Date	Expiration	Release	Page
05.2013	05.2015	1	1

DUST INFILTRATION IN EVAPORATOR COMPARTMENT Prevost vehicles

Figure 1

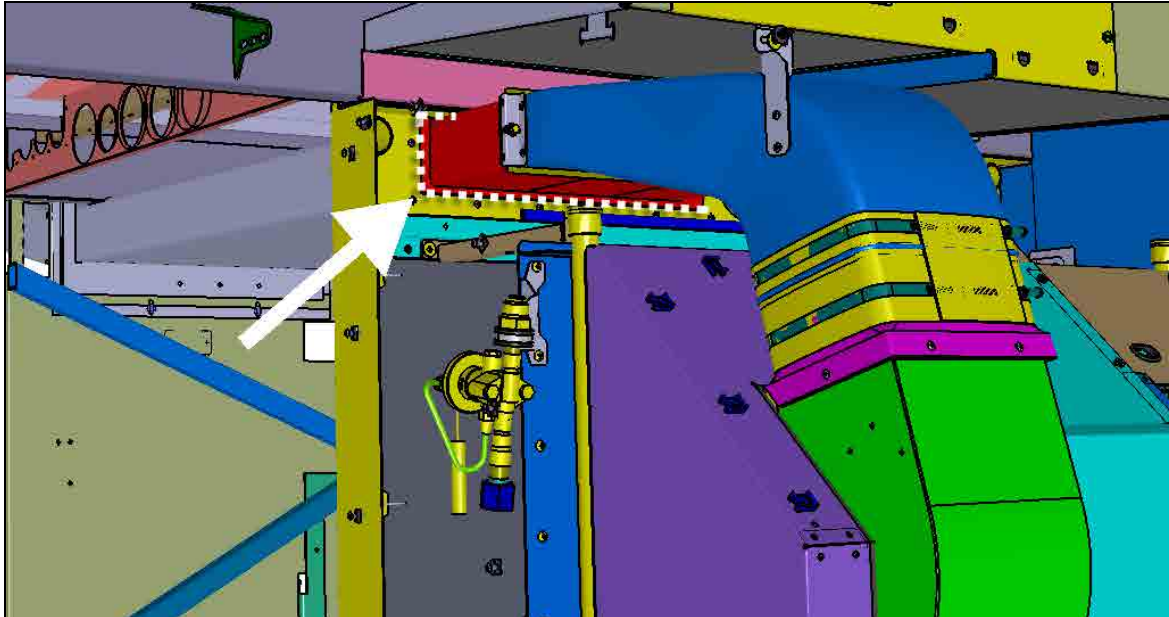
Seal at the indicated location where the duct leading to curb side goes through the wall. (Fig 1)
Then, seal the wall junctions with floor and ceiling between the fore luggage bay and the evaporator compartment.

Figure 2

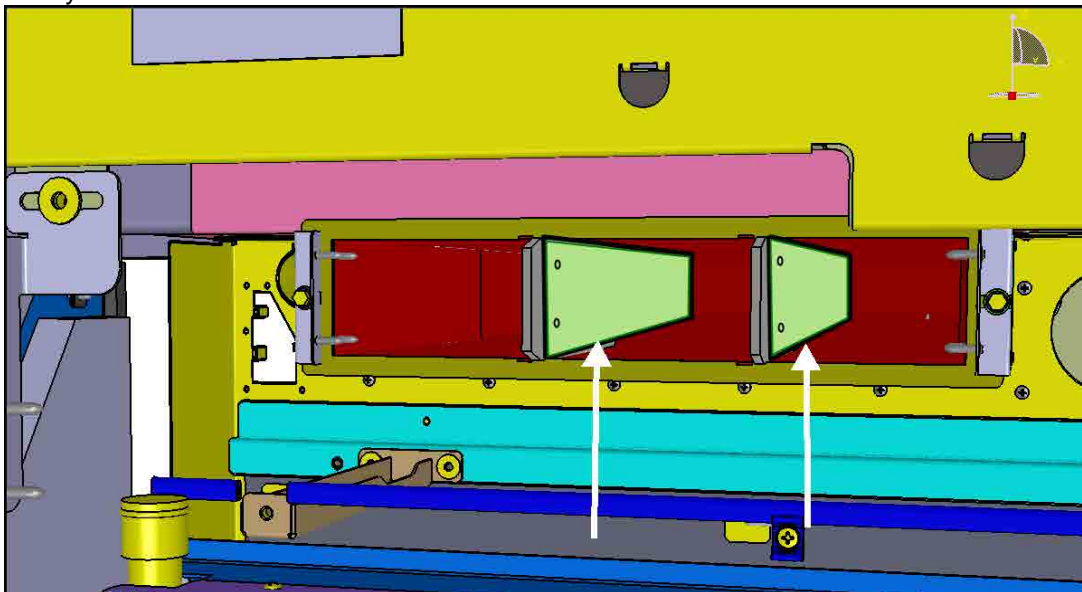
Add support ribs made out of 3/16 thk plastic sheeting (Fig 2) inside the duct to help prevent duct top sheet to bend down under the weight of accumulated dust and road debris. Secure to existing baffles with locally available hardware.
